**TOWN OF PLAINFIELD  
BOARD OF ZONING APPEALS REPORT**

**CASE NO.:** BZA-20-147; BZA-20-148; BZA-20-149

**PETITIONER:** Hendricks Therapy Plainfield

**REQUESTED ACTION:** BZA-20-147 Development Standards Variance of Article 4.10 Table 4.10-A Drive Aisle  
BZA-20-148 Development Standards Variance of Article 2.11B 2(c) Rear Yard Setback  
BZA-20-149 Development Standards Variance of Article 2.11B 2(b) Side Yard Setback

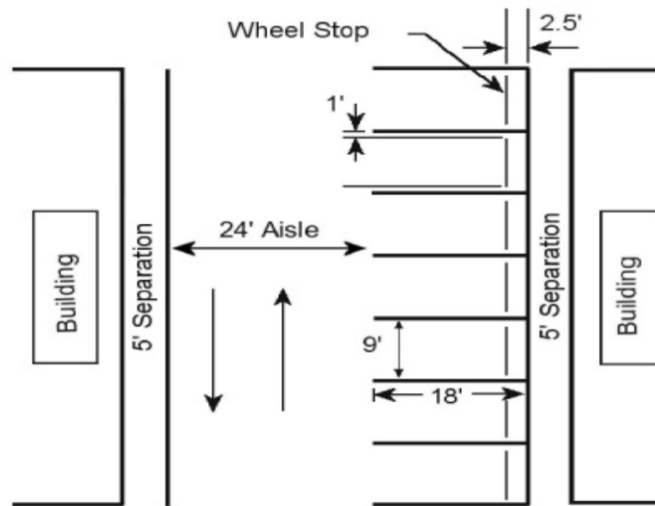
During the review of the existing site and planning for the proposed remodeling of the existing facility, it was determined that parking areas on the east side of the existing building do not meet the current requirements as well as the drive aisles on the east and north sides of the building.

The existing drive aisle on the east side of the building is 20.8 feet wide; the existing drive aisle on the north side of the building is 13.4 feet.

1. The original development plan was approved in 1997 and an amendment to add on to the structure approved in 2002. The parking lot (parking spaces and aisles) was a part of that review and approval. These issues have been in existence since that time. Staff knows of no issues with the current site through the years concerning the existing parking plan.

2. This applicant's request is more of a need to formalize the parking lot plan with official review and correction of an existing non-conforming condition with approved status.

3. These requirements were in place at the time of original approval and it is not clear how the actual conditions occurred.
4. The planned site improvements will make insignificant changes to the amount of hard surface area and as a result, there will be no measurable change to the amount of stormwater runoff. No major storm sewer or detention improvements are anticipated.
